DELHI DEVELOPMENT AUTHORITY  
(MASTER PLAN SECTION)

Minutes of the 77th meeting of Technical Committee held on 27.5.97 at 10.00 A.M. in the Conference Hall, 5th floor Vikas Minar, I.P. Estate, New Delhi.

FIGURE -1

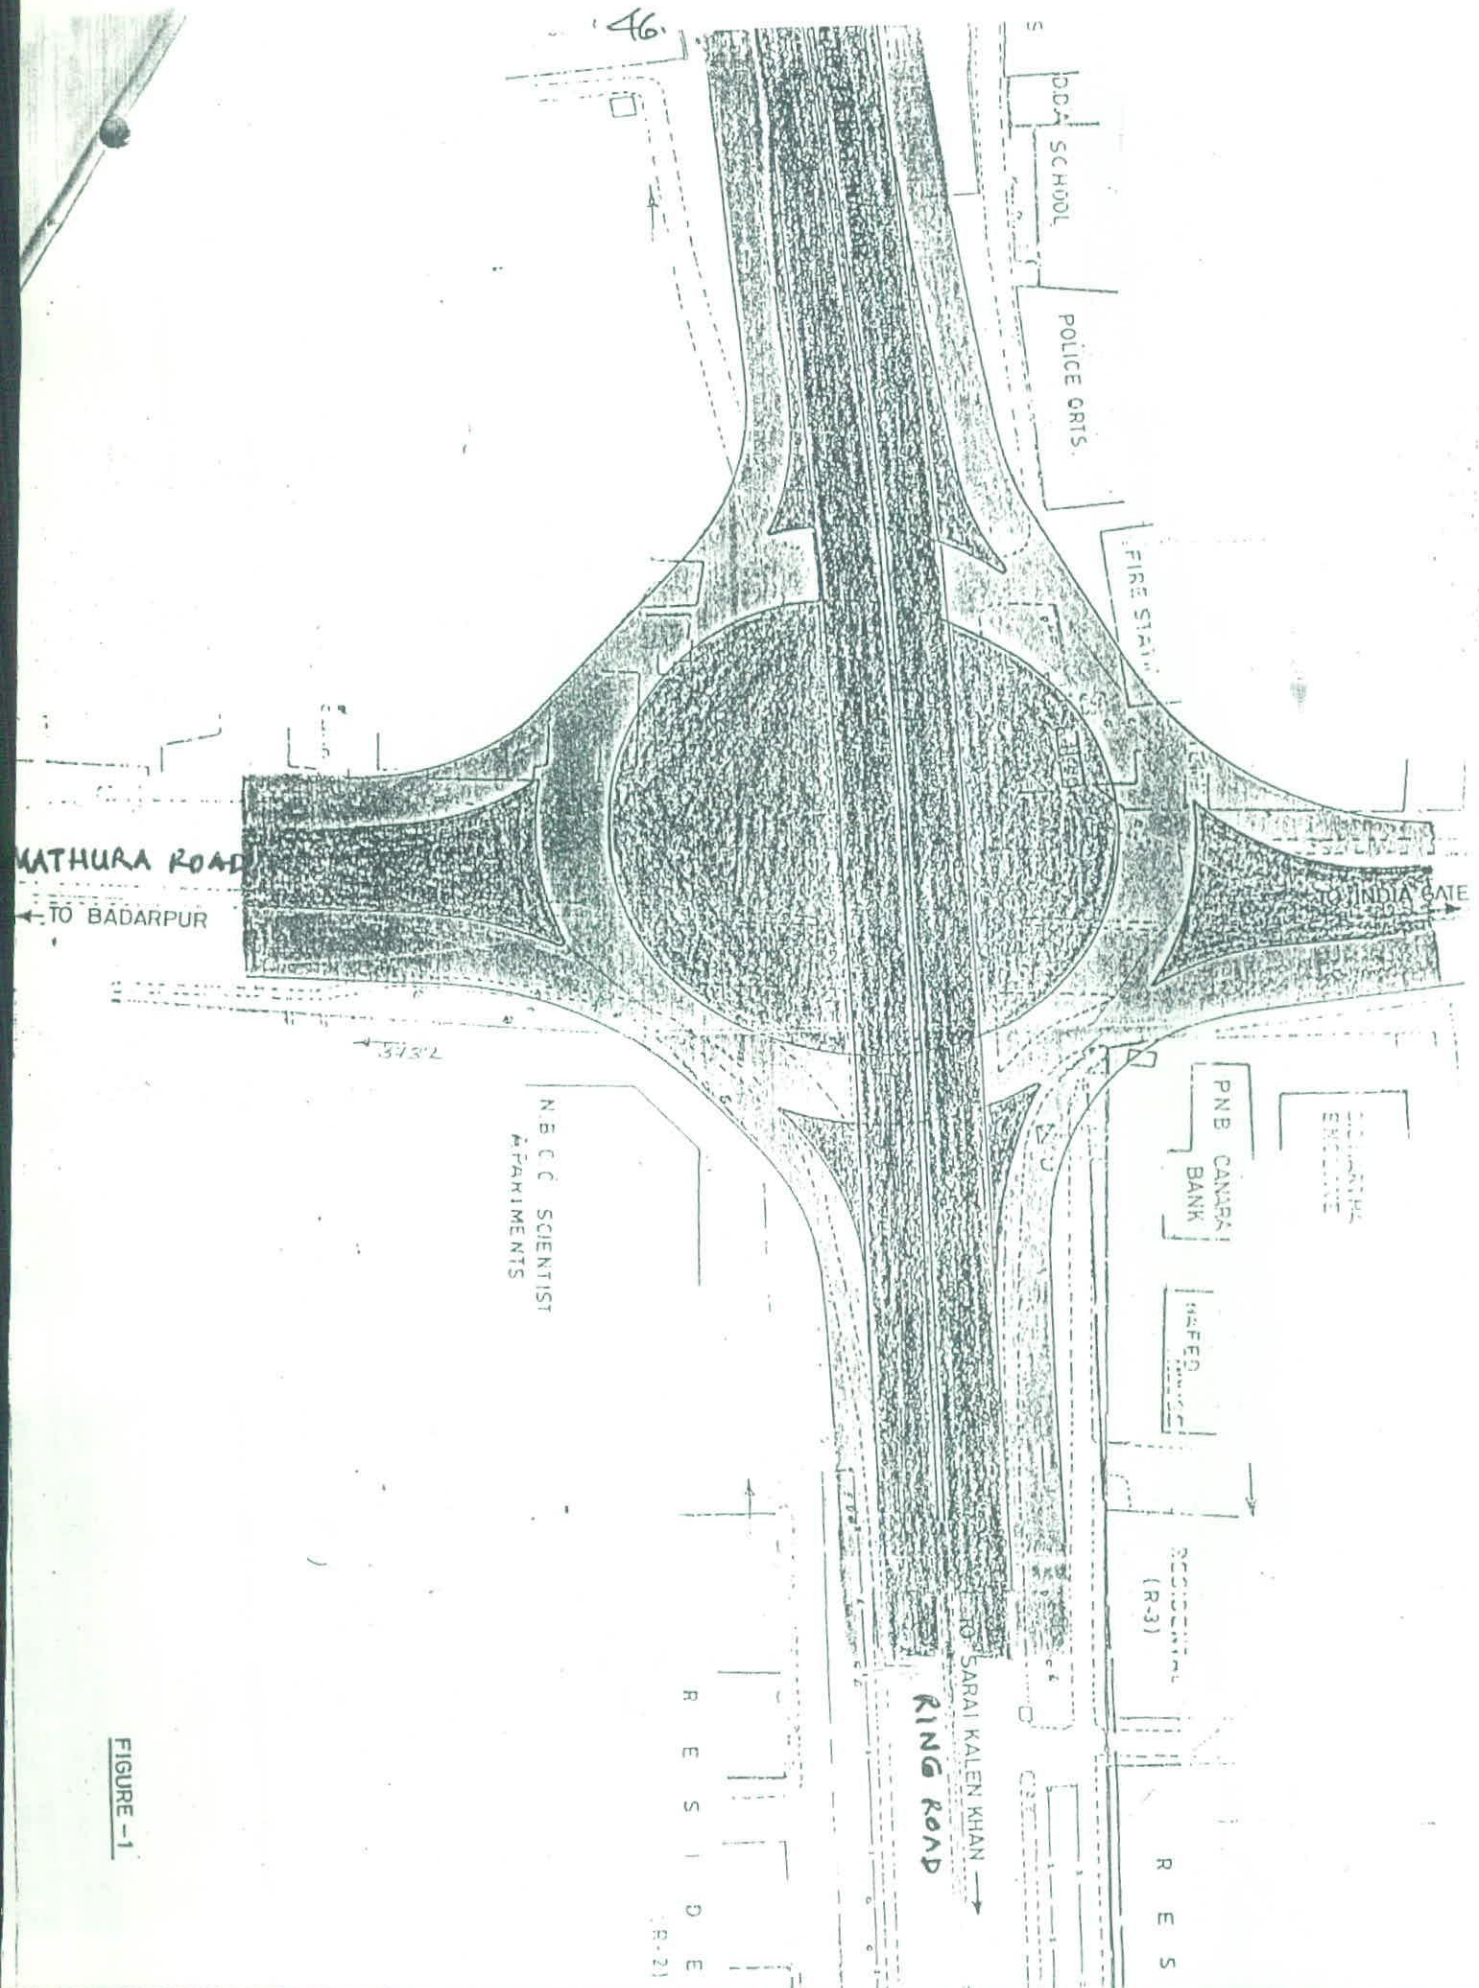
This scheme would occupy 18045 sq.m. area of land and the cost would be Rs.14 crores. It may be noted from **Figure 1** that the Ring road through movements are through elevated Ring road. NH2 through movements and all right turning movements are through at grade rotary. To achieve the high efficiency at grade rotary, the acquisition of corner of fire station building is required. Initially the rotary would provide for smooth flow of traffic. In long term, if direct connection to NH24 connecting Lodhi Road and NH2 bypass is provided then elevated Ring road with at grade rotary would be a better option. Else by 2010, rotary will warrant signalization in both peaks of the day. The rotary central island will be provided with landscaping to create harmony with the environment.

FIGURE - 2

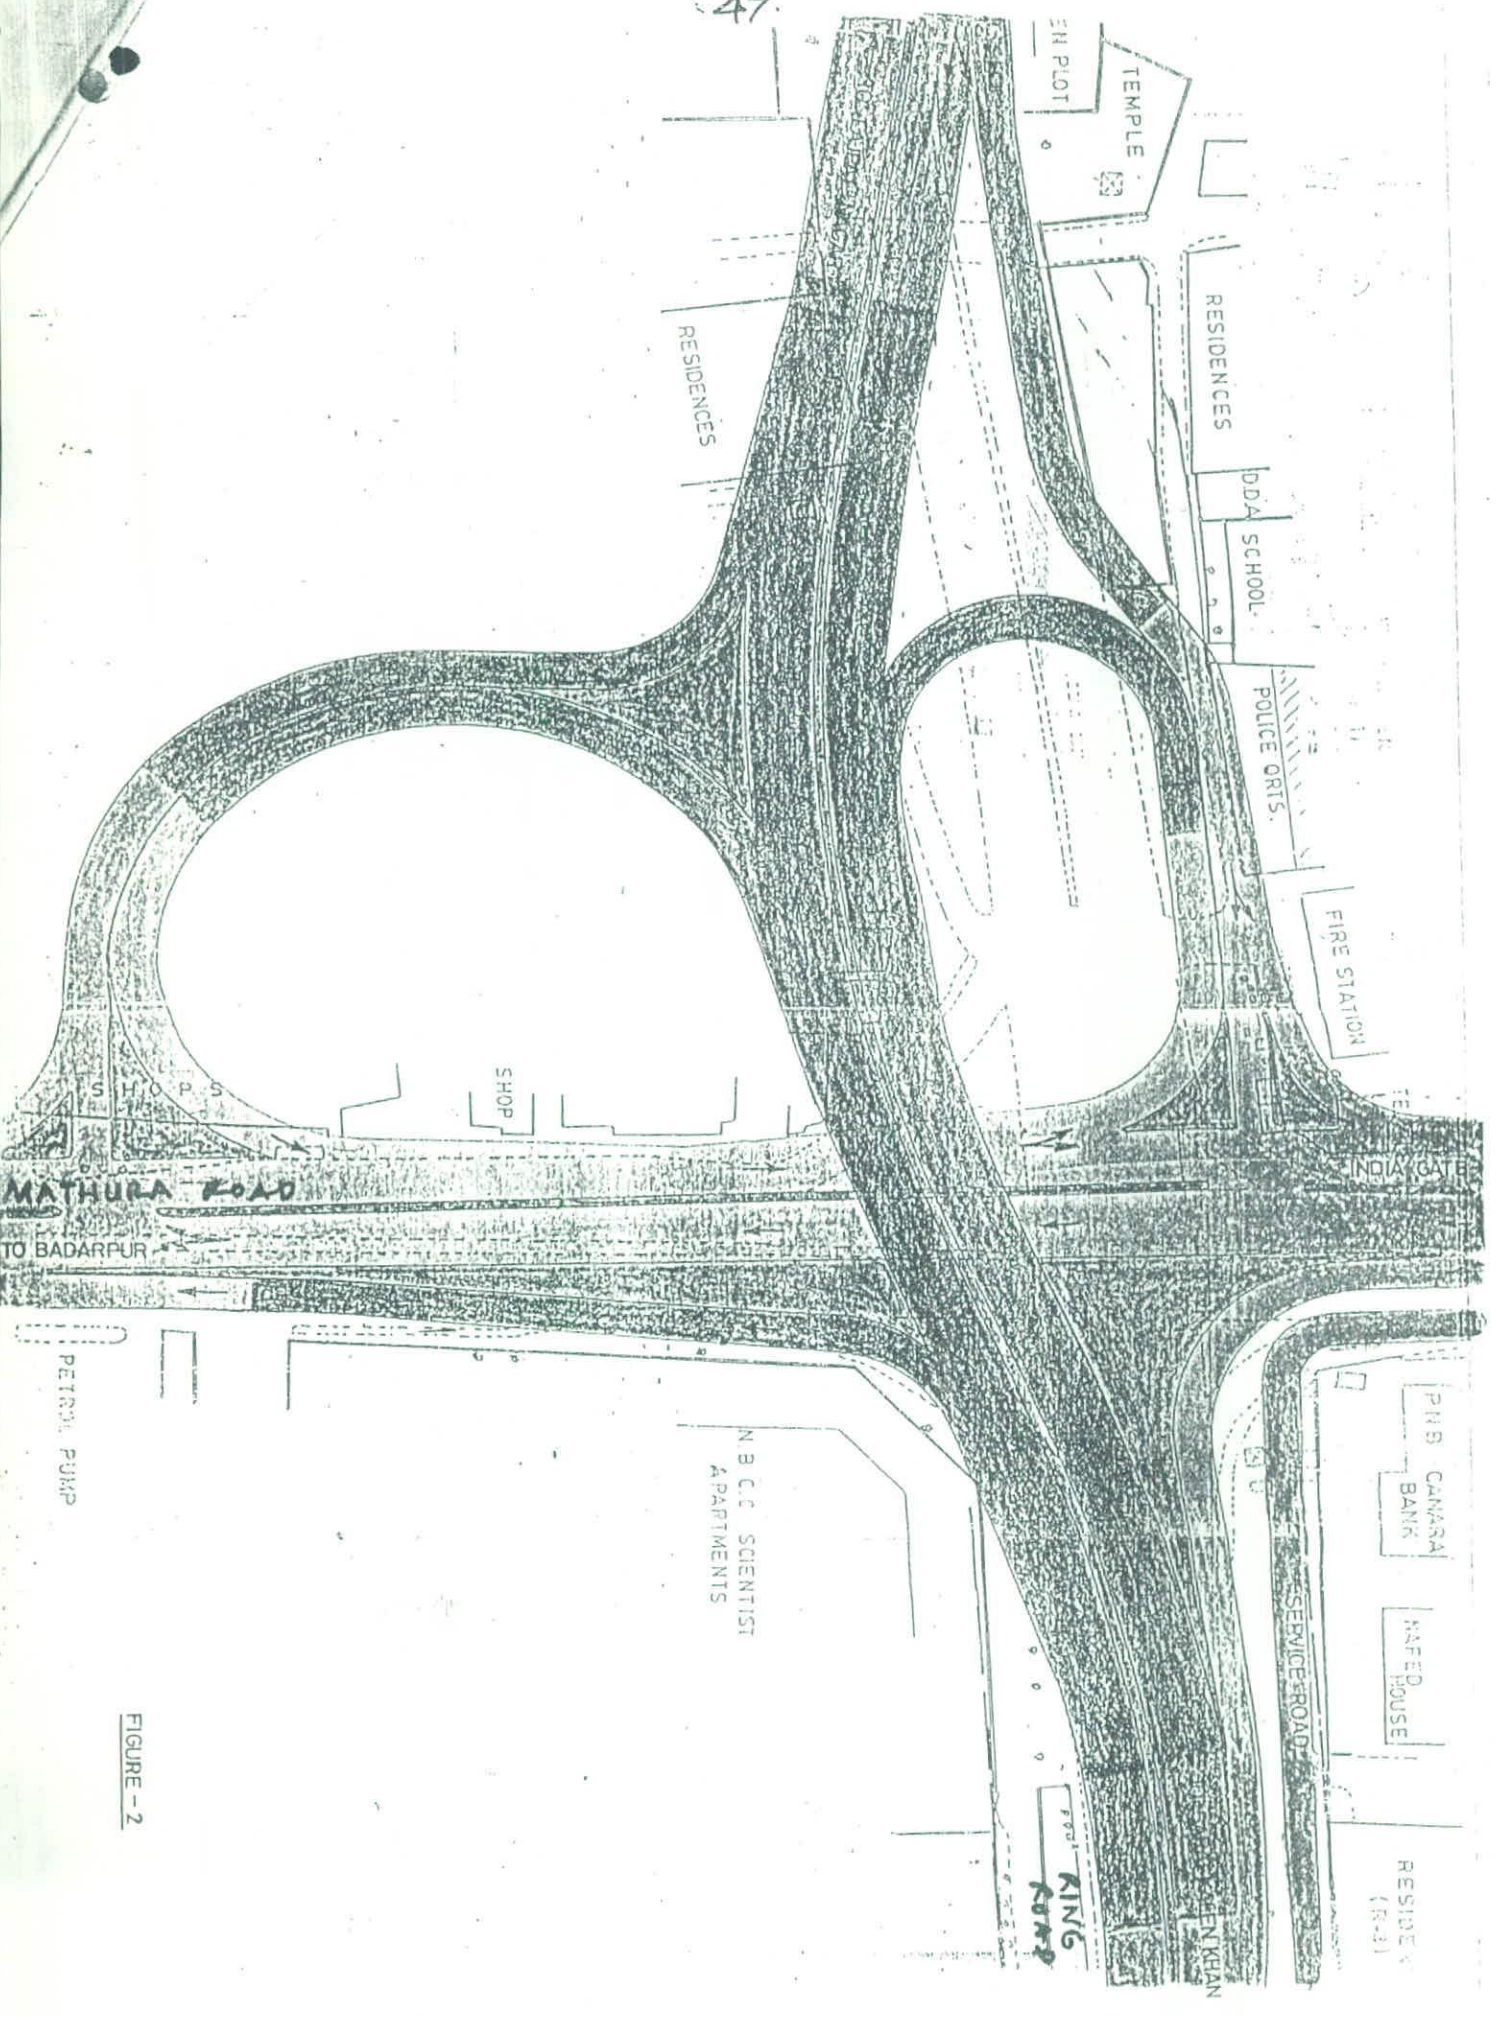
This scheme would occupy an area of 43937 sq.m land and cost would be Rs. 15.5 crores. It may be noted from **Figure 2** that the two major right turning movements are through loop ramps. The vertical clearance for elevated Ring road is 5.5m to accommodate double decker buses. One of the loop ramps (5W) would be constructed over earth embankment and adequate landscaping be provided to create harmony with the environment. The planning and design of the North Western loop is complicated due to the presence of fire station and circulation of the areas in the vicinity of fire station. Thus this loop has been planned in such a way that it would be consistent with the general circulation plan of the fire station area without affecting any structure. Very limited space is available for loop at this site, hence space has been created by shifting the Ring road alignment towards south. The shifting of this Ring road is constrained by existing R.O.B. in west and CSIR multistoreyed building in North East. Due to these constraints it was not possible to sign loop ramps with a radius of curvature of 60m radius and the minimum radius curvature of 30m (IRC:92-1985) has been provided. This form of interchange with two loops opposite each other would require two intersection
